RE: REVISED ALTAMIRA DRAINAGE REPORT (FORMERLY THE SHORES)

Re: Drainage Update for ALTAMIRA

STORM DRAINAGE STUDY
RELATIVE TO SITE PLAN DEVELOPMENT FOR
THE SHORES SUBDIVISION
ALBUQUERQUE, NEW MEXICO

FIGURE 1

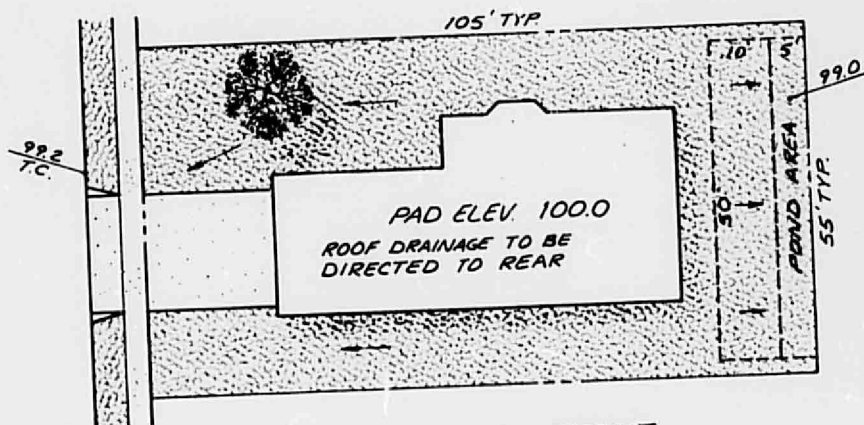
Thank you for the copy of the D6, J21 drainage report. I have reviewed this report for content and found it satisfactory. The only update other than the name of the subdivision is the configuration of the TYPICAL LOT LAYOUT.

Transmitted with this letter is the drainage report with the updated lot layout. I am returning these items for your review and files.

The referenced drainage plan submitted 6/17/83 is approved.
